Re: St. Lucie Plant Unit 2
Docket No. 50-389
Renewed Facility Operating License No. NPF-16

Response to NRC Reactor Systems Branch Request for Additional Information
Regarding Extended Power Uprate License Amendment Request

SXRB-120

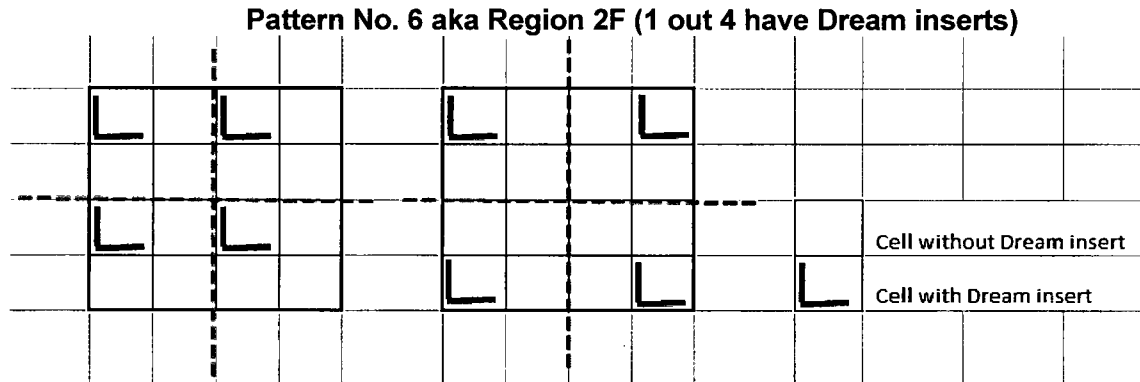
a) The proposed technical specifications (TS) include the following language:

The storage arrangements of fuel within a rack module may contain more than one pattern. There are no interface limitations within Region 1 between rack modules or within racks; however, each assembly must meet the burnup requirements of each 2x2 array that it resides within.

Depending on how "each 2x2 array that it resides within" is interpreted, the proposed TS may not clearly implement the language from Section 2.6.1 of the analysis. Section 2.6.1 says all overlapping patterns must meet one of the analyzed cases, while the TS could be interpreted as not applying to overlapping 2x2 arrays. Each storage cell is part of up to four 2x2 arrays. Each storage cell must simultaneously meet the requirements of all arrays of which it is a part. The current TS could be interpreted as it would only have to meet one. Provide a revised TS that ensures each storage cell must simultaneously meet the requirements of all arrays of which it is a part.

b) The analysis modeled all of the 2x2 arrays with periodic boundary conditions. This creates a repeating set of 2x2 arrays. The proposed TS state, "Diagram is for illustration only." This indicates the adjacent 2x2 array may actually be different, even though it would meet the definition for the same pattern.

In the proposed TS, case 6 is Pattern "F" shown in Figure 5.6-2 and defined by definition No. 3. The TS definition states that there must be at least one Metamic insert placed anywhere within the 2x2 array.

Based on the TS definitions and figures, it would appear acceptable to have a 4x4 array with Metamic inserts on the 4 corners of the 4x4 array. As shown in the figure below, this would leave a central 2x4 array that does not have an insert. Has such a configuration been evaluated?

There may be a disconnect between the analysis and the proposed TS which does not appear to require that overlapping sets of 4 assemblies using the same case (i.e., case 6) meet the subregion requirements.

Is it required that any and all, including overlapping, 2x2 assembly sets within a subregion (i.e., case 6) must meet the definition for that subregion? If not, describe how the criticality analysis supports the proposed TS with regard to arrangement variations within a subregion (i.e., area filled with same pattern definition).

- a. The EPU LAR proposed changes to Technical Specifications are being revised to address this RAI and are being submitted under separate correspondence.
- b. See Attachment 2 response to RAI SRXB-120 b.
